**Community Development Department**

**NOTICE OF DECISION**  
 Atlas – Site Plan Review

<b>Land Use Application Nos.:</b>	SPR 20-010 (Site Plan Review) BLA 20-006 (Boundary Line Adjustment) SEP 20-015 (SEPA) CAP 20-004 (Critical Areas Permit)
<b>Applicant:</b>	Samuel Duguay Jackola Engineering and Architecture 702 Jefferson ST Vancouver, WA 98660
<b>Property Owner:</b>	Sarah and Kaarle Homola 428 N Pekin RD Woodland, WA 98674
<b>Site Location:</b>	428 N Pekin Woodland, WA 98674
<b>Parcel &amp; Size:</b>	50739, 50741, 50740, 3.69 Acres
<b>Zoning Designation:</b>	Heavy Industrial (I-2)
<b>Date Application Received:</b>	December 14, 2020
<b>Notice of Application &amp; Likely DNS issued:</b>	January 22, 2021
<b>Comment Period &amp; SEPA Appeal Period Ended:</b>	February 17, 2021
<b>Notice of Decision Issued:</b>	March 11, 2021
<b>DRC Decision:</b>	Approve with Conditions

**Attachment A**  
Site Plan

**2 NORTH ELEVATION**  
 1/8" = 1'-0"

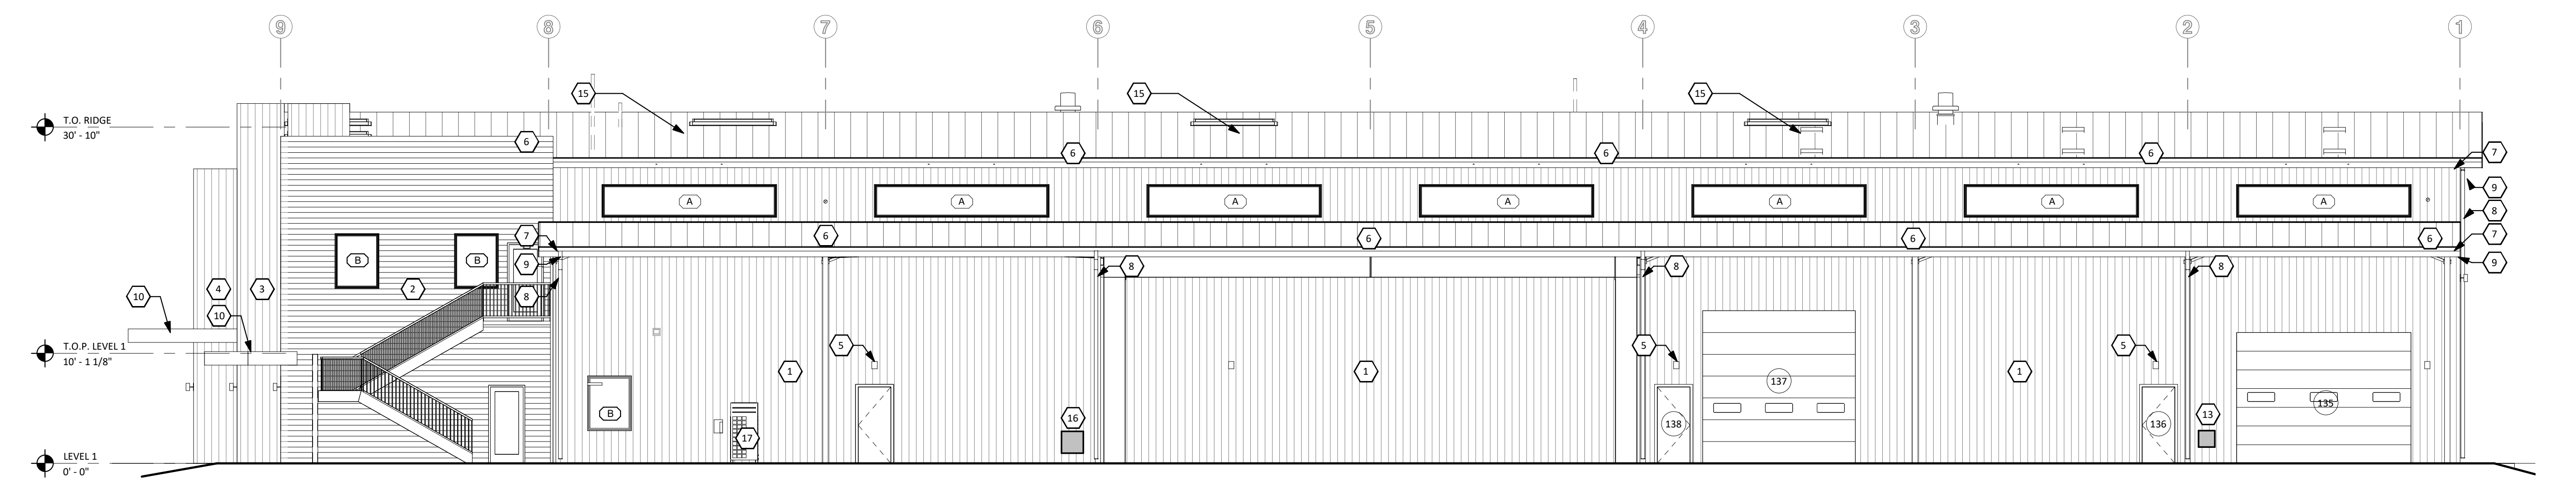
**Finding 66:** The north and west building elevations face the street and must meet the façade standards in WMC 17.46.160 (C). The north and west building elevations do not meet the standard. A condition is added to revise the building elevations to comply with WMC 17.46.160 (C). *See Condition #29. See Attachment B – Building Elevations.*

29. The north and west building elevations face the street and must meet the façade standards in WMC 17.46.160 (C). Revise the building elevations to comply with WMC 17.46.160 (C). Resubmit building elevations with the final civil engineering and revise prior to submitting building permits.
